7 October 2014

Brian Gibson
Senior Development Planner
Lake Macquarie Council
126-138 Main Road
SPEERS POINT NSW 2284

DA251/2013 Masters Windale: Response to Request for Information

Site Plan

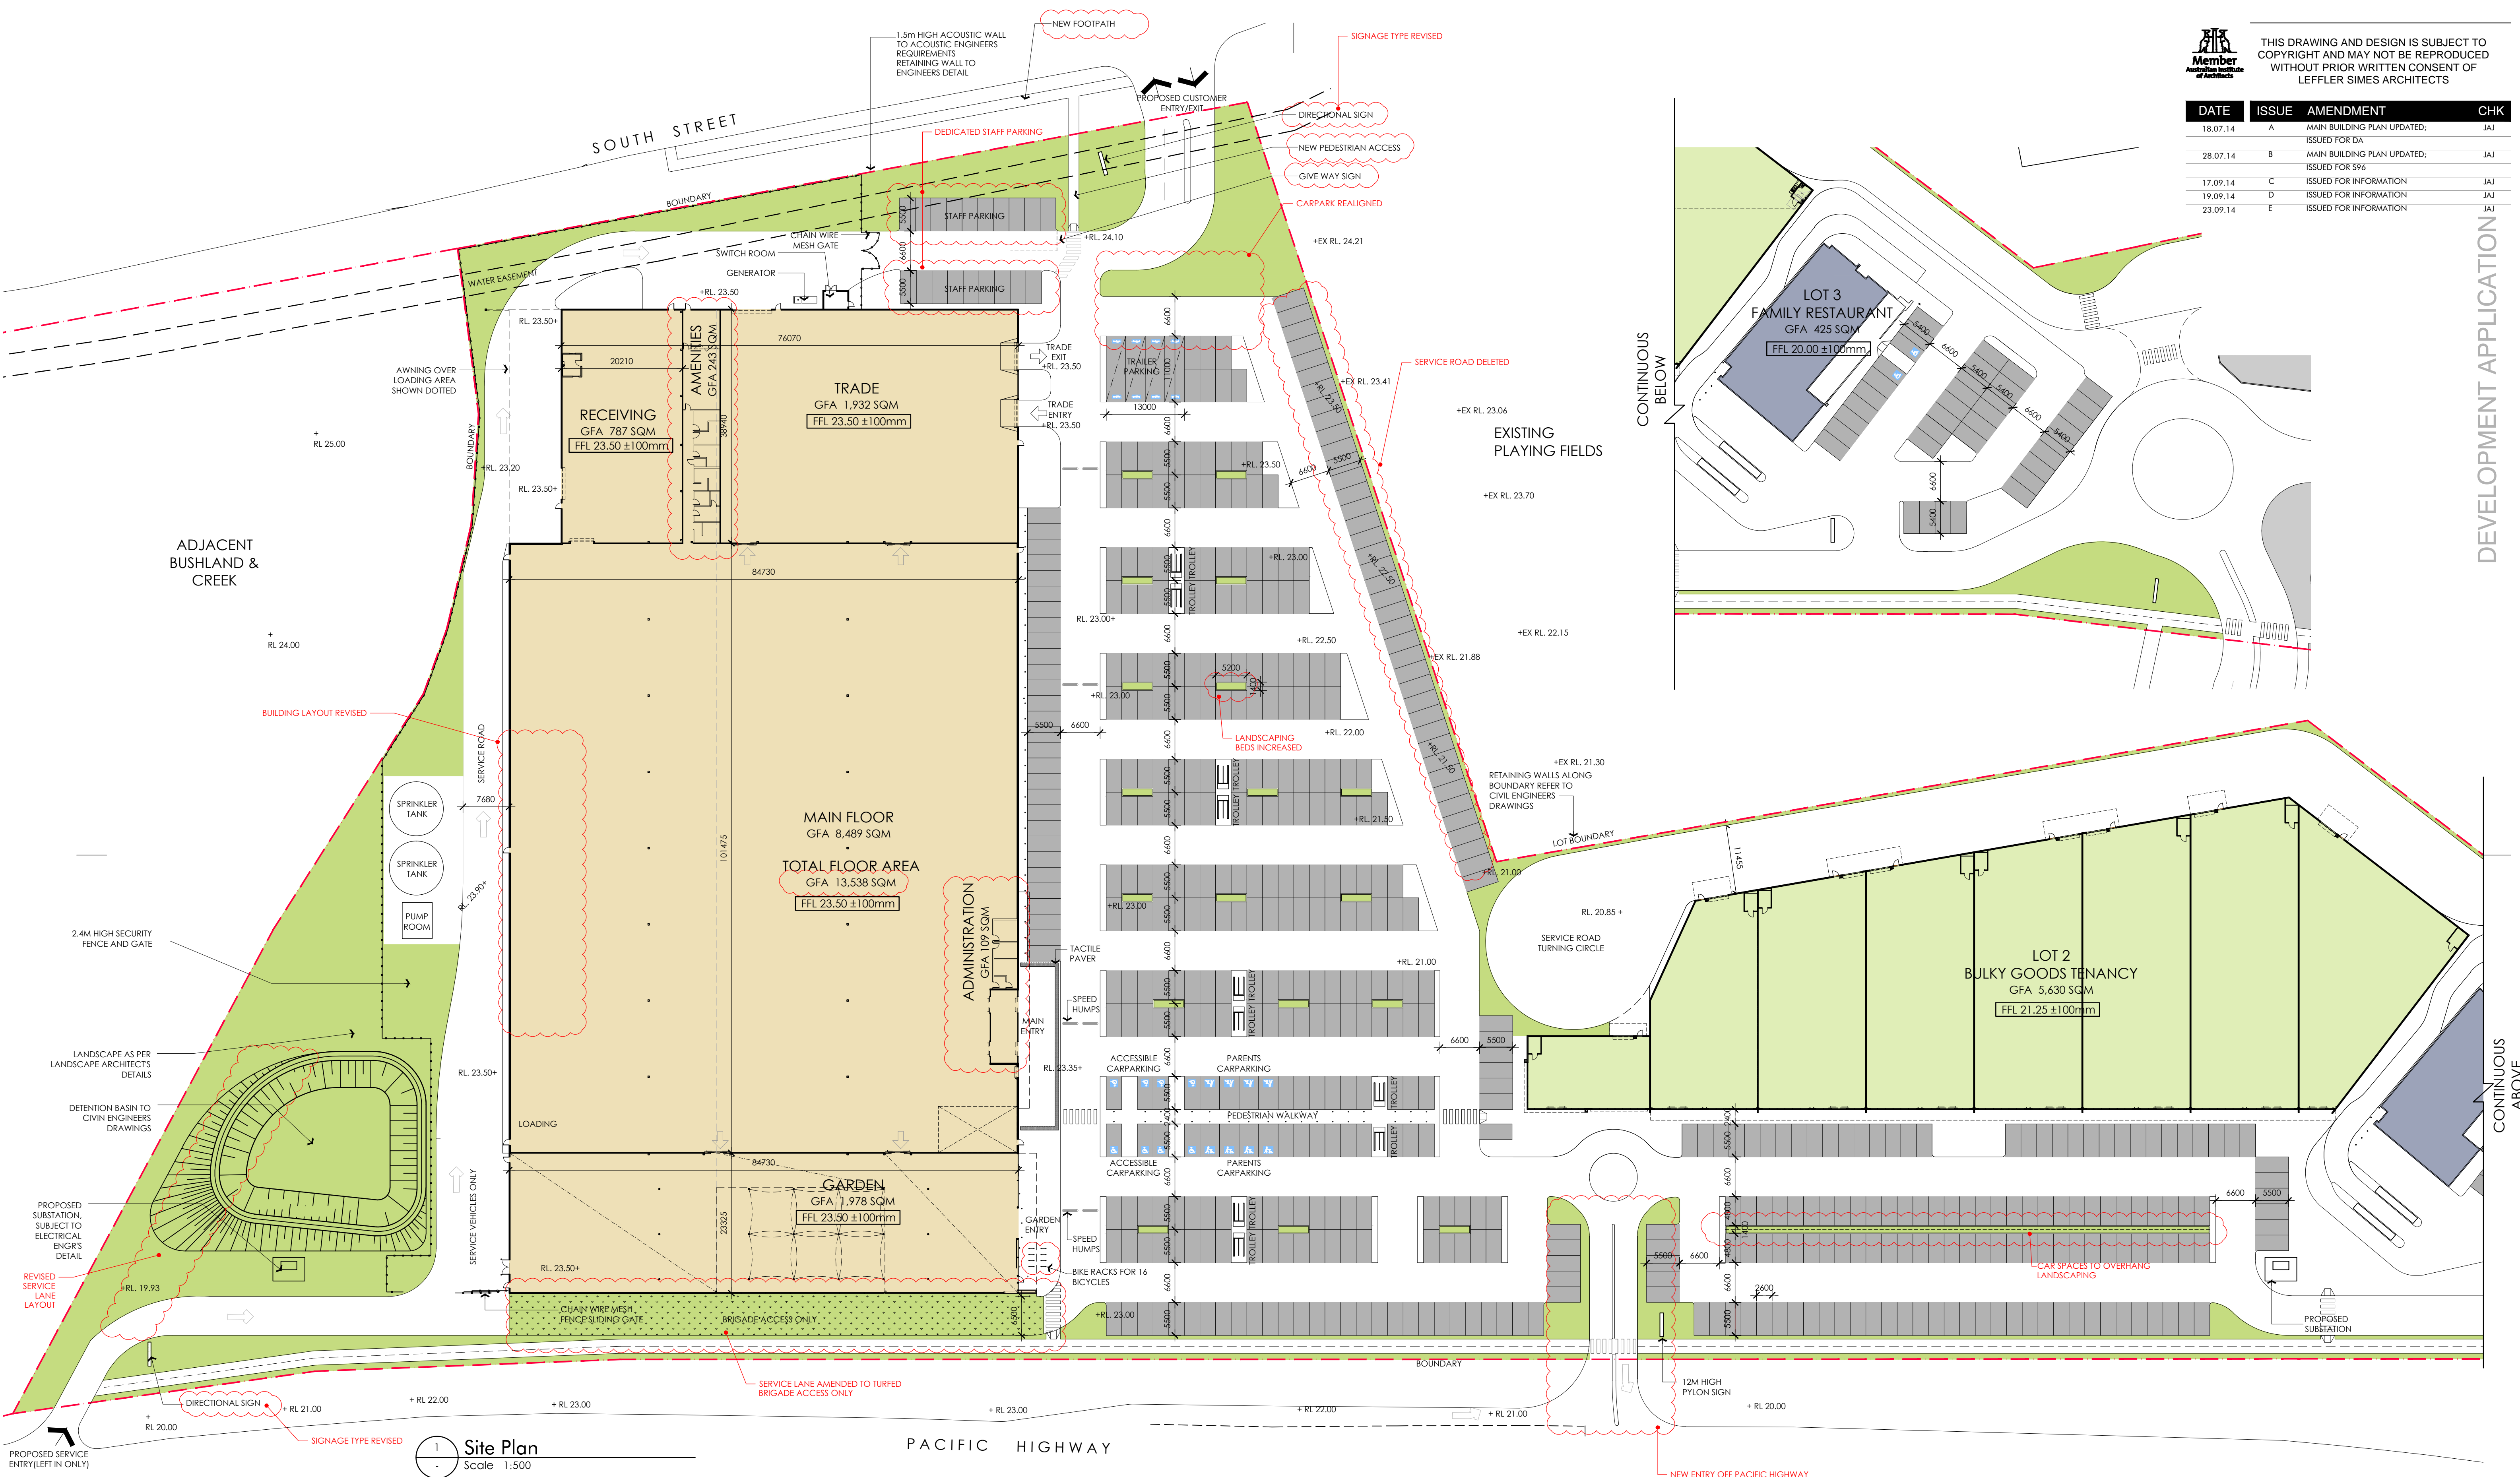
- *'Give way' provisions on the service road* – Give way signs have been added and are shown on the revised Site Plan.
- *Signage for heavy vehicles and customer vehicles* – A 'give way' sign has been added at the northern end of site near service road as shown on the revised Site Plan.

- *There is a pedestrian crossing which leads nowhere across the service road* – This has now been deleted from the Architectural Plans.
- *Footpath connection from South Street and Lake Street into the site* – This footpath is now provided and shown on the revised Site Plan.

Roof Plan

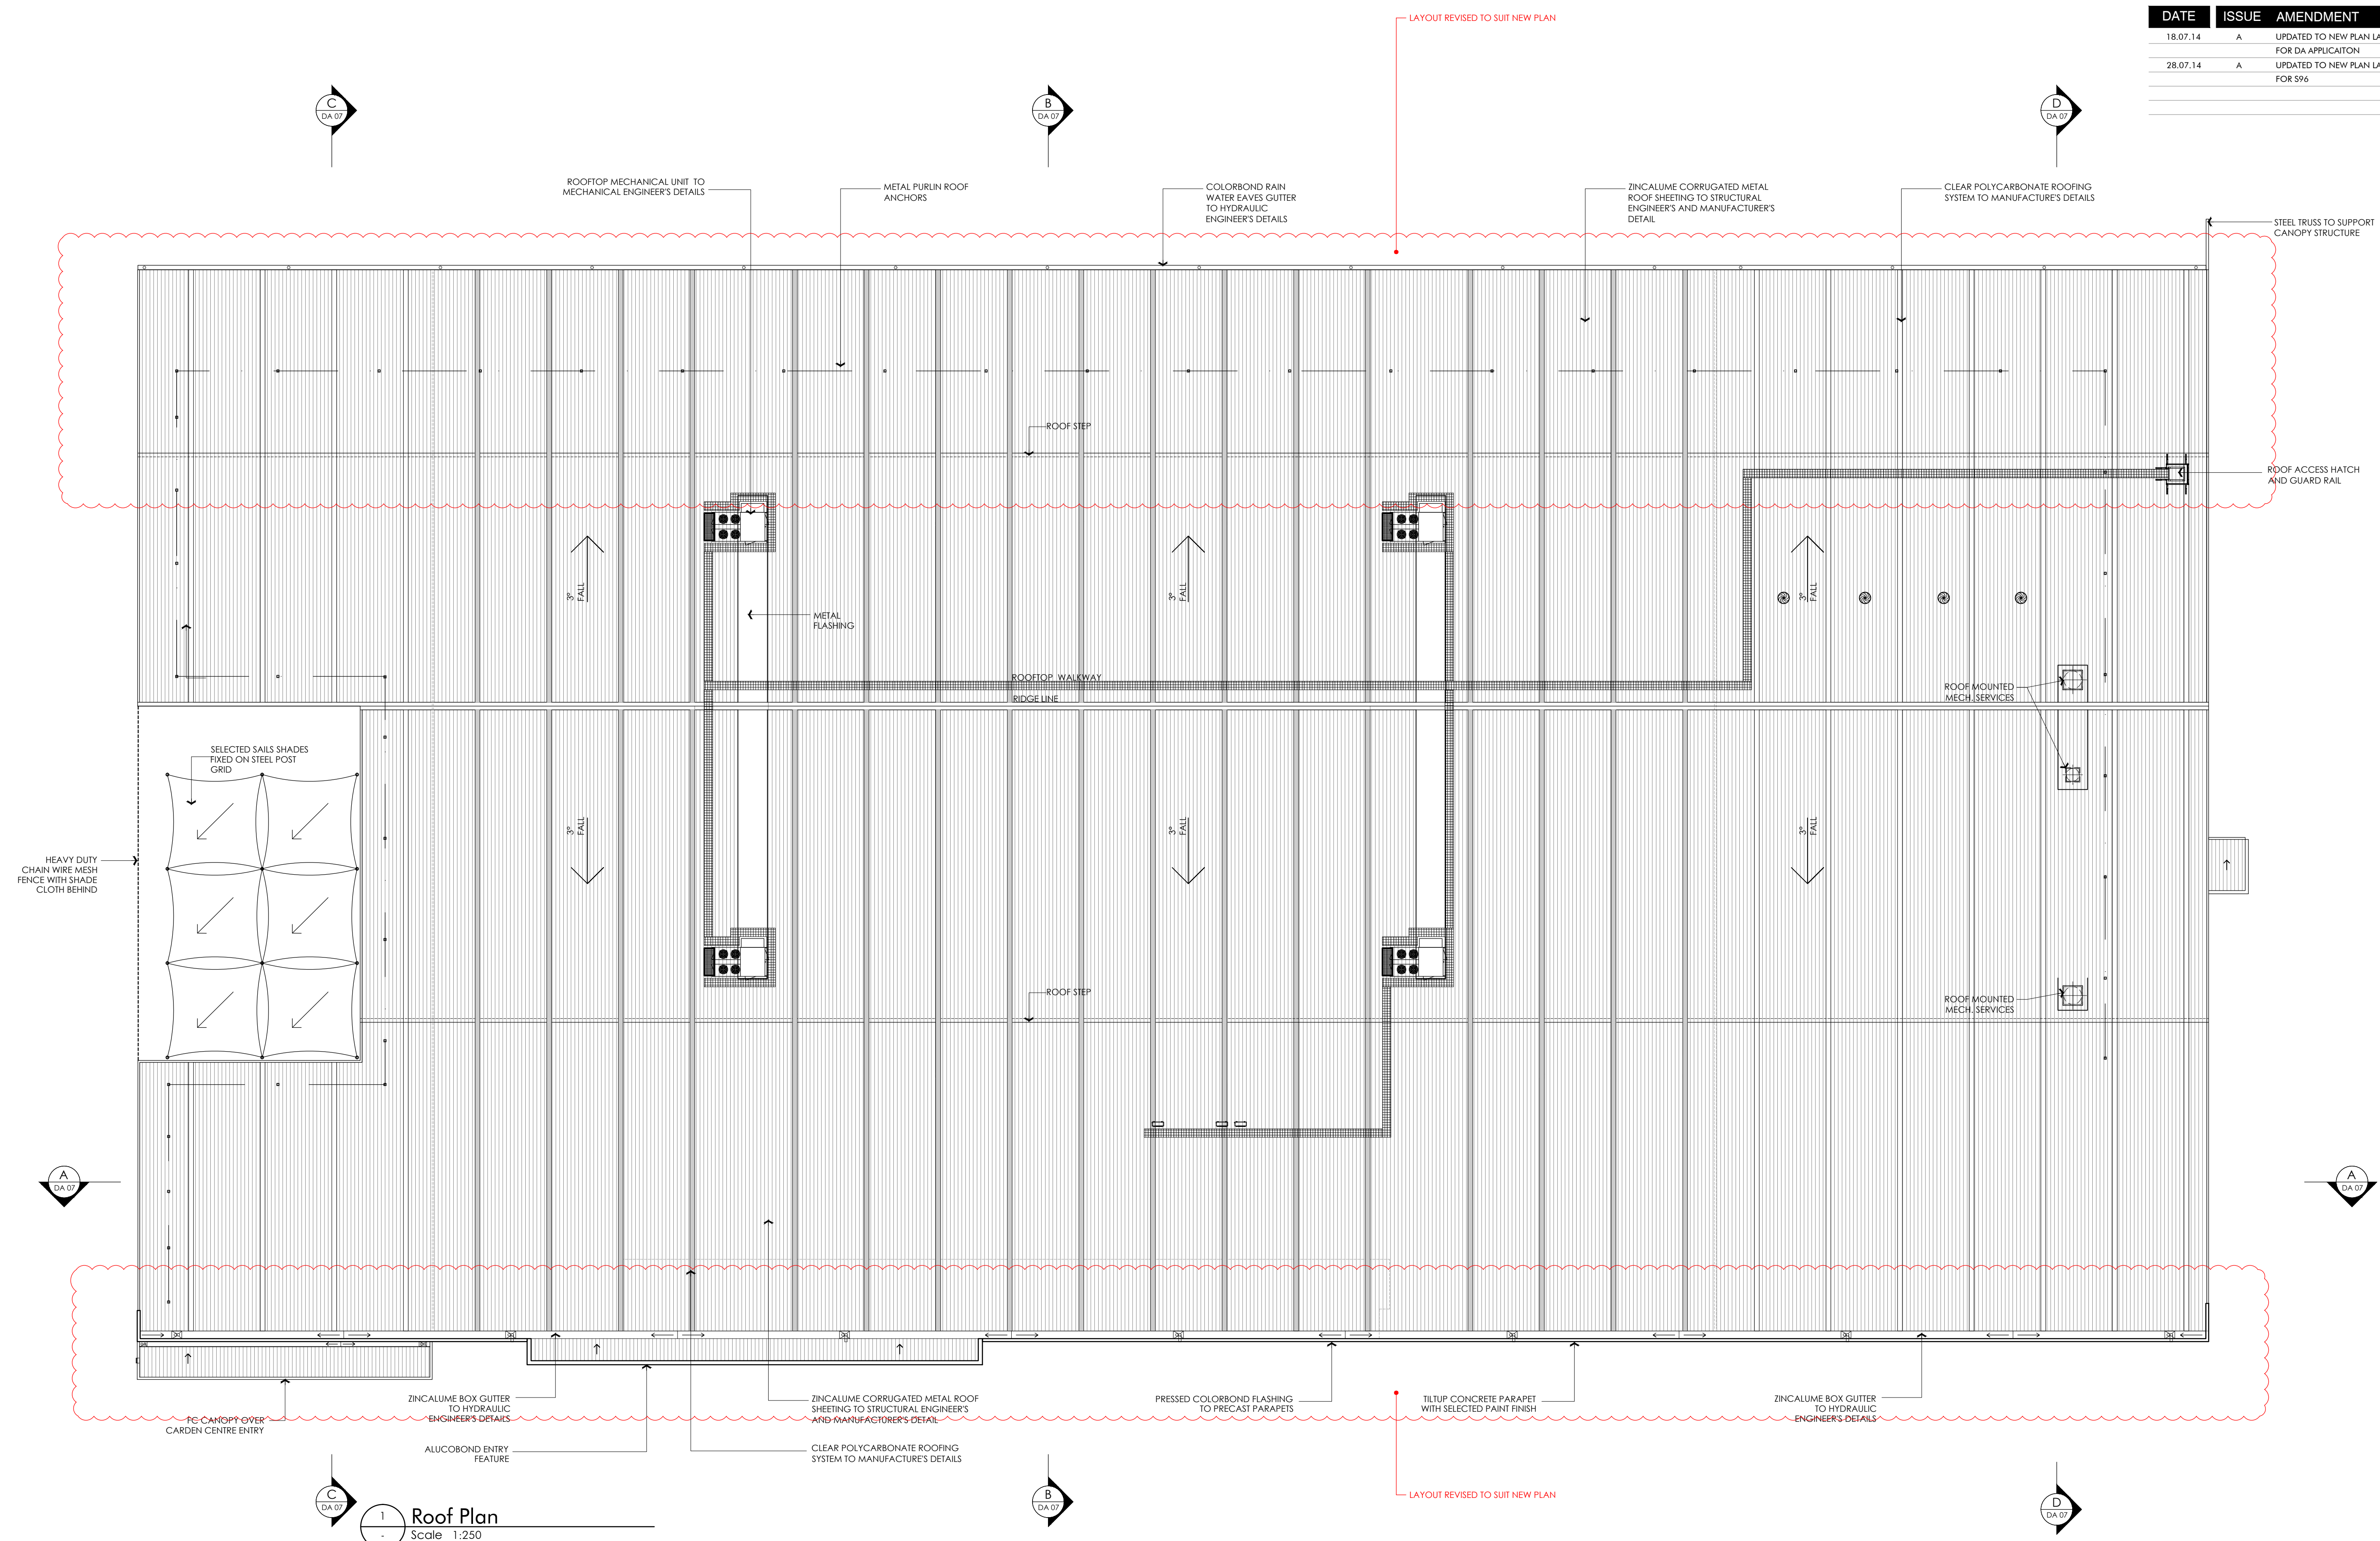
Council requested that the roof plant be screened as it will be visible to elevated residential areas to the west. **Figure 2** show how the units will appear on the rooftop.

In order to present the most visually appealing built form when viewed from the site and immediate surrounds, we request that council reconsider the requirement to screen the roof plant.

Elevations

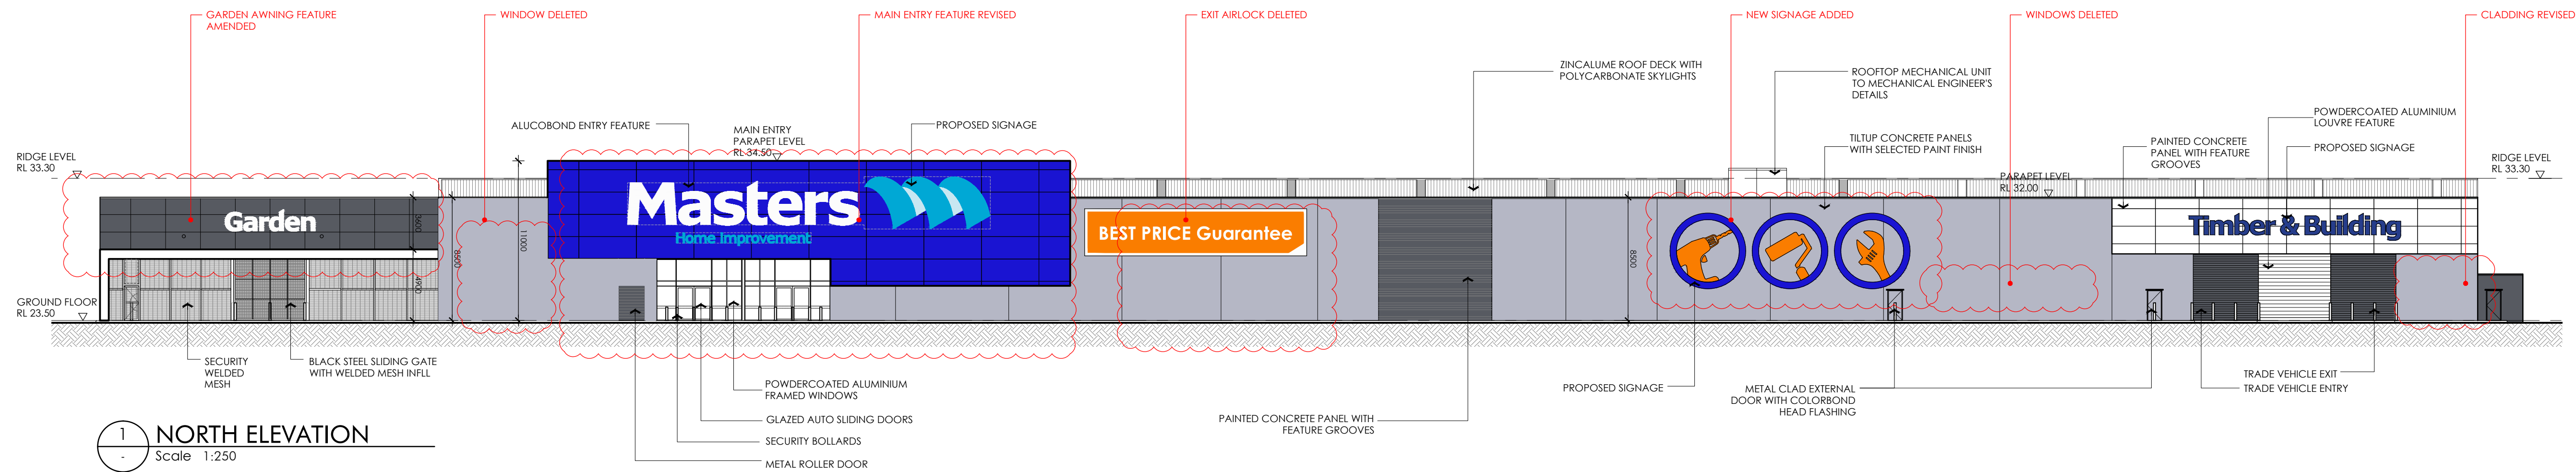
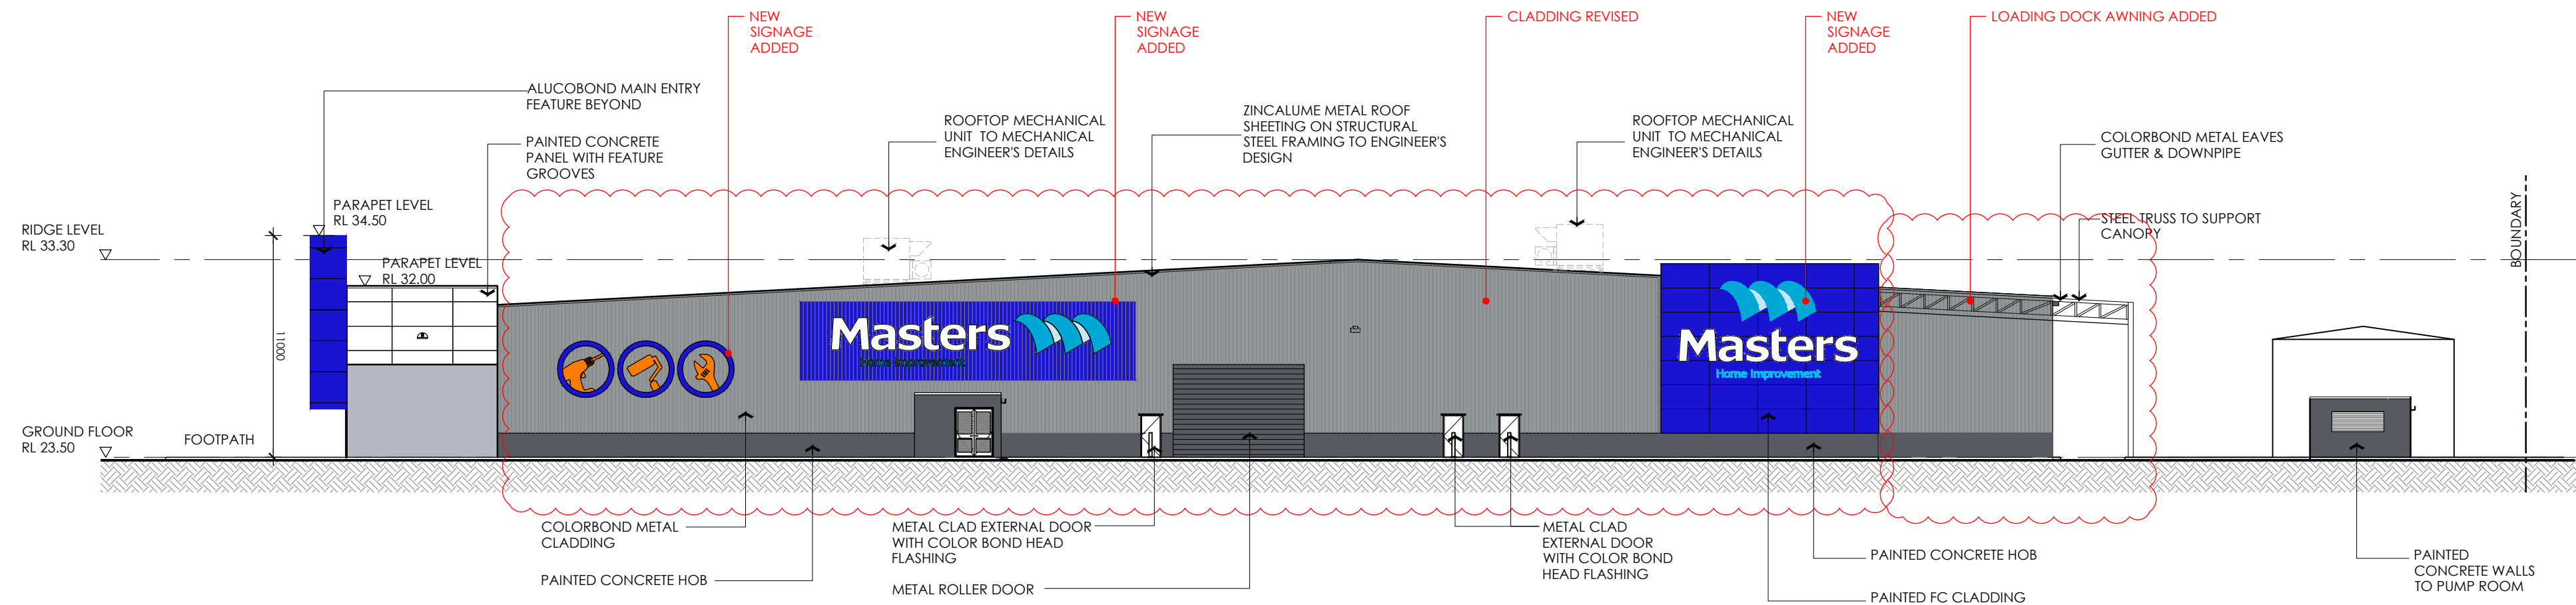
The western façade of the Masters Home Improvement Centre facing South Street has been reviewed in context of Council's request to provide an improved design response to the adjacent residential area. Further articulation has been provided through variation in parapet heights and materials. Blue FC sheet cladding is proposed with expressed joints and additional signage with iconography has also been provided. This is shown on the amended elevations provided in **Attachment A**.
